RENESAS TECHNICAL UPDATE

Product Category	SRAM	Document No.	TN-PME-A001A/E	Rev.	1.0
Title	Notice about the switch to lead-free parts on SRAMs		Information Category	Package Change	
Applicable Product	256Kbit/1Mbit/2Mbit/4Mbit/ 8Mbit/16Mbit Low Power SRAM 4Mbit Fast SRAM 18Mbit Network SRAM	Lot No.	Reference Document	-	
		A.S.A.P.

Process change notice for Renesas SRAM products

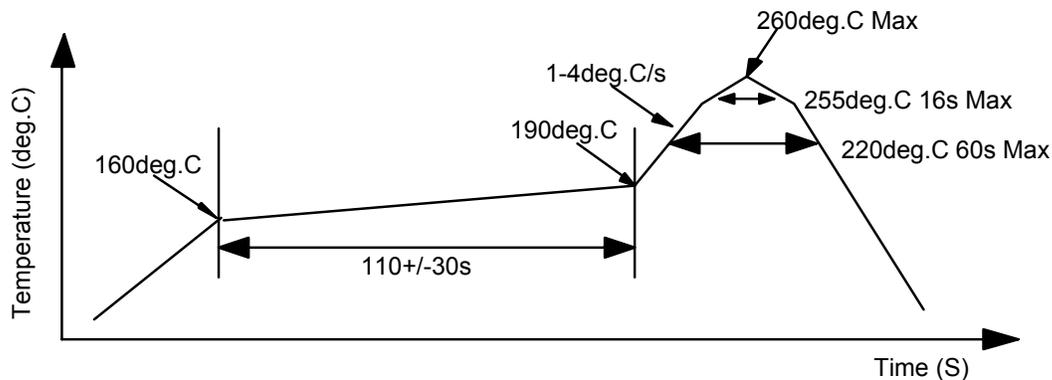
(b)Renesas has also completed examinations against package thermal endurance based on the thermal profile (peak temp.=260deg.C) shown in Fig.1 and confirmed good results for Renesas all SRAM products.

As mentioned, we confirmed there was no problem on thermal endurance for our all SRAM products under the condition of the following temperature profile shown in Fig.1. And also we confirmed no problem on solderability. However the differences on temperature profile and/or solder paste material between Renesas and customers could be sometimes seen. Therefore we would recommend you to confirm solderability by yourself.

Fig. 2 Temperature cycling results of board-mount FBGA

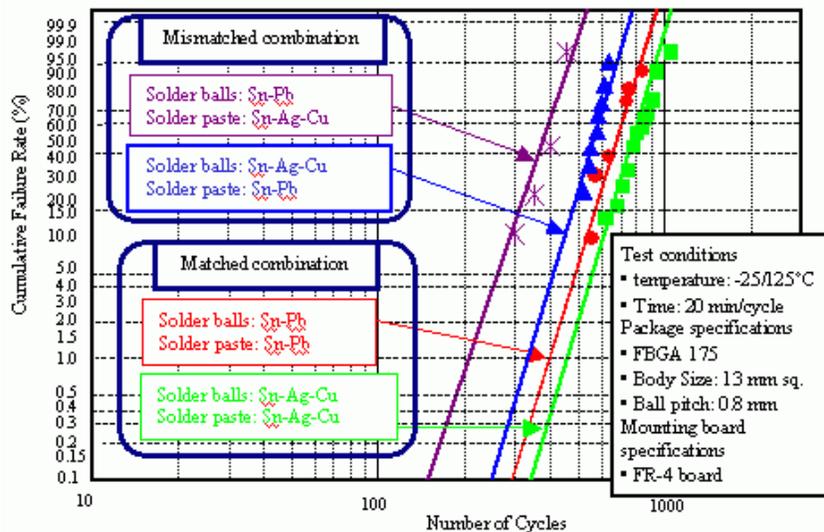
The mismatched combinations (different materials between balls and paste) are undesirable because of smaller number of cycles to failure, compared with the matched combinations (same materials between balls and paste).

Renesas recommends the use of Sn-Ag-Cu lead-free pastes, which composition is also used for BGA balls' material, for soldering lead-free BGAs. If other types of pastes are used, please confirm mountability and solder joint reliability according to your methods and criteria.

Fig. 5 Impact strength test results

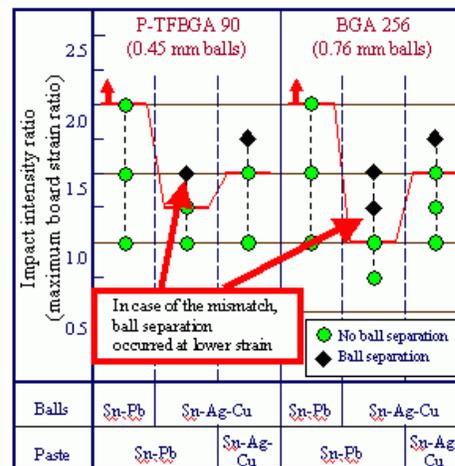
When strong mechanical impact is applied to boards on which BGAs are mounted, ball separation may occur. We performed the mechanical impact test shown in Fig. 3 to compare impact strengths of mismatched and matched cases. It was found that ball separation in the mismatched case occurred with weaker impact than in the matched cases as shown in Fig. 5. Mismatched combination is therefore undesirable because of lower mechanical impact resistance.
